Access Compliance Report

Public Rights-of-Way

(Curb Ramps)

Intersection ID: 11685	Main Street: E_19TH_ST	Cross Street: SEIGLE_AV	Location: SW
ADA ID: DEBB349B8196	Ramp Type: Perp	Initial Pass/Fail: Fail	Overall Compliance: No
Severity Score: 13.75			
Codes/Mitigation Info/Possible Solution		Field Measurements/Component Compliance

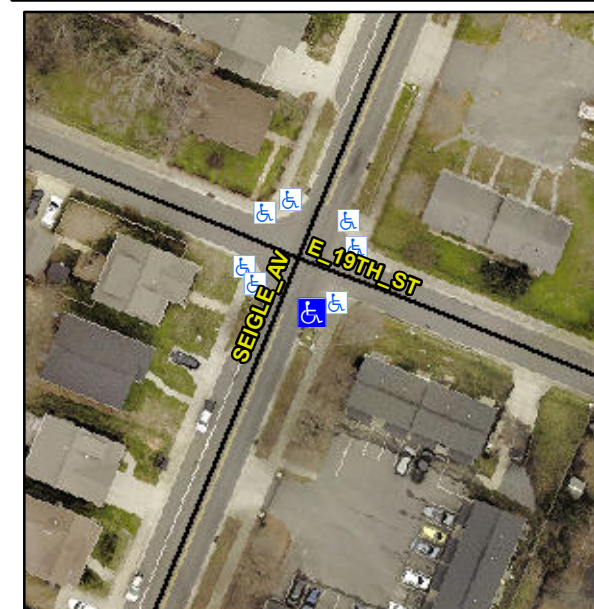
Not Found, R304.2.2, R304.5.3

Compliance	Description	Data	Compliance	Description	Data
N/A	Ramp Length (in)	74.0	No	Ramp Slope (%)	8.5
Yes	Ramp Width (in)	48.0	No	Ramp XSlope (%)	4.9
N/A	Flare Type LT	N/A	N/A	Flare Type RT	N/A
N/A	Flare Slope LT (%)	N/A	N/A	Flare Slope RT (%)	N/A
N/A	Flare Traversable LT?	N/A	N/A	Flare Traversable RT?	N/A
N/A	Landing Length (in)	N/A	N/A	DWS Provided?	N/A
N/A	Landing Width (in)	N/A	N/A	DWS Contrast?	N/A
N/A	Landing Slope (%)	N/A	N/A	DWS Length (in)	N/A
N/A	Landing X Slope (%)	N/A	N/A	DWS Full Width?	N/A
N/A	Landing Curb? (Y/N)	N/A	N/A	DWS Offset (in)	N/A
N/A	Shared Landing?	N/A			
N/A	Gutter Ponding?	N/A	N/A	Gutter Slope (%)	N/A
N/A	Gutter Lip Ht (in)	N/A	N/A	Gutter X Slope (%)	N/A
N/A	Painted X Walk1?	No	N/A	Painted X Walk2?	N/A
	X Walk 1 Direction	To NW		X Walk 2 Direction	N/A
N/A	X Walk 1 Width (in)	N/A	N/A	X Walk 2 Width (in)	N/A
	X Walk 1 Slope (%)	2.1		X Walk 2 Slope (%)	N/A
	X Walk 1 X Slope (%)	3.5		X Walk 2 X Slope (%)	N/A

Remove & Replace Entire Ramp.
